MINOR VARIANCE REPORT

APPLICATION: CAV A/183/2022

Owner/Applicant	Agent	Location of Land
Shuyu Zheng 1019 Bridge Road Oakville ON L6L 6T4	UnikHouse Inc c/o Zhe Wang 201-80 Fulton Way Richmond Hill ON L4B 1J5	PLAN 805 LOT 17 1230 Donlea Crescent Town of Oakville

Subject Property

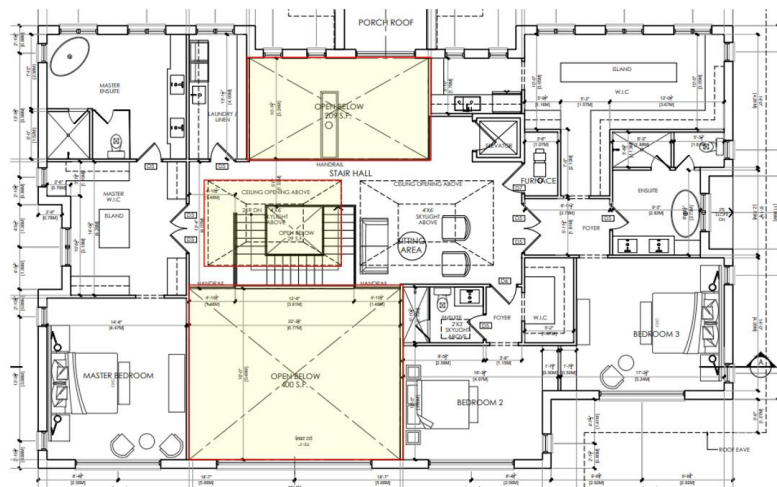
The applicant is requesting relief from Zoning By-law 2014-014, as amended, to permit an increase in the maximum residential floor area ratio from 29% (404.55 square metres) to 31.90% (445.01 square metres) for an increase of 40.46 square metres. The intent of regulating the residential floor area is to prevent a dwelling from having a mass and scale that appears larger than the dwellings in the surrounding neighbourhood. The proposed design of the dwelling includes large open to below areas which serves to push the second storey floor area to the perimeter of the dwelling which would create a mass and scale that would be considered an over building on the lot. Staff are of the opinion that the requested variance is not minor in nature and will have adverse effect on the surroundings.
